OYSTER CREEK NUCLEAR GENERATING STATION, UNIT NO. 1

AMENDMENT TO PROVISIONAL OPERATING LICENSE

Amendment No. 24
License No. DPR-16

SAFETY EVALUATION BY THE OFFICE OF NUCLEAR REACTOR REGULATION

FIGURE 3.10.1

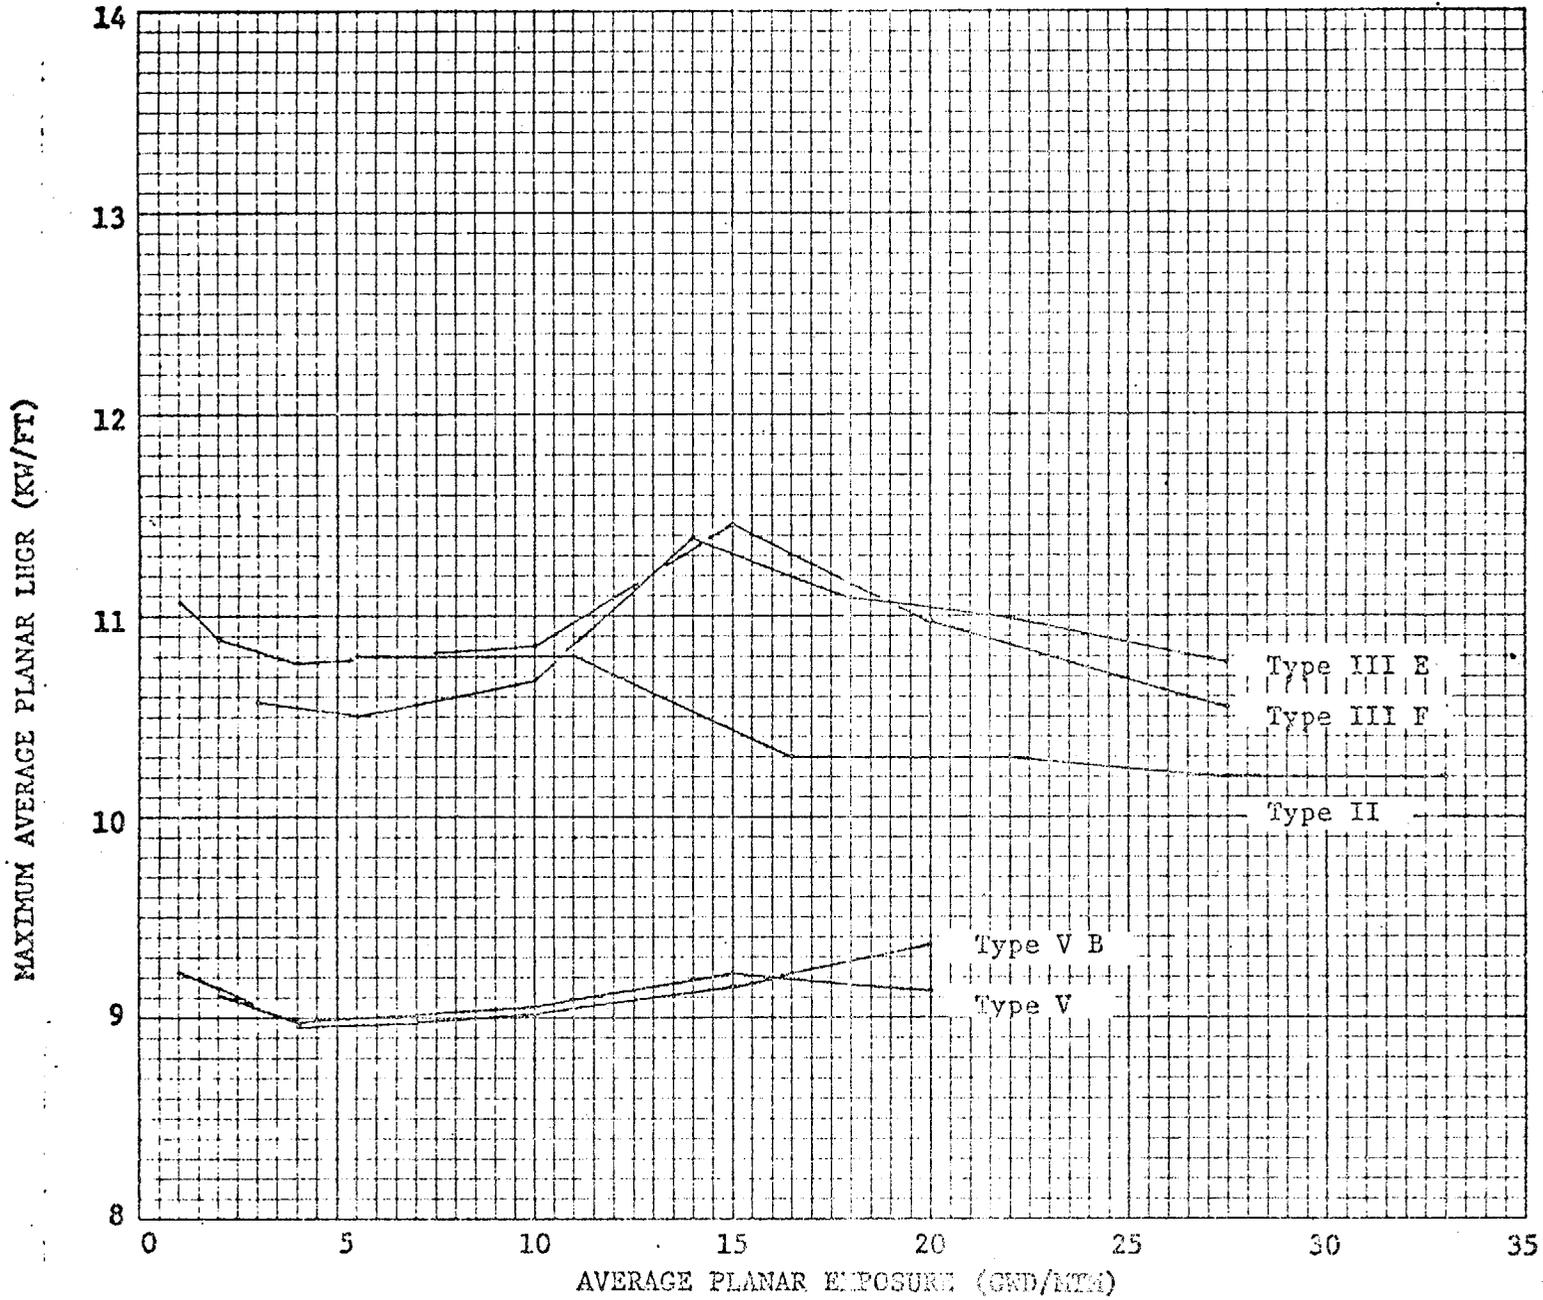
The amendment modifies the Technical Specifications to delete specifications and bases applicable to fuel types I and III which are no longer in the Oyster Creek core and to extend the MAPLHGR curves for the fuel types still in the core.

In the application for amendment, JCP&L has extended the Maximum Allowable Average Planar Linear Heat Generation Rate specification for fuel types currently in the core by modifying Figure 3.10.1. This modification extends the calculated Maximum Average Planar Linear Heat Generation Rate (MAPLHGR) from 15 GWD/MTM (thousand megawatt days/metric ton) to 20 GWD/MTM for fuel types V and VB, from 20 GWD/MTM to 27.5 GWD/MTM for fuel type IIIF and from 22 GWD/MTM to 27.5 GWD/MTM for fuel type IIIE. The calculated MAPLHGR for fuel type II was not extended.

The extensions of MAPLHGR shown in Figure 3.10-1 for types IIIE, IIIF, V, and VB fuel are the results of an analysis using an approved ECCS evaluation model in agreement with Appendix K to 10 CFR Part 50. This LOCA analyses, performed by Exxon Nuclear Company (ENC), utilized blowdown

results obtained from General Electric Company which reflect revised single failure considerations. In addition, the MAPLHGR extensions shown in Figure 3.10-1 for types V and VB fuel were analyzed with 100% of the spray cooling coefficient specified in Appendix K to 10 CFR Part 50 for 7 x 7 fuel.

We have reviewed the proposed changes and have concluded that they do use the methods found acceptable by the NRC staff, do not change MAPLHGR limits previously found acceptable and only extend the current calculations to higher fuel exposures and therefore are acceptable.
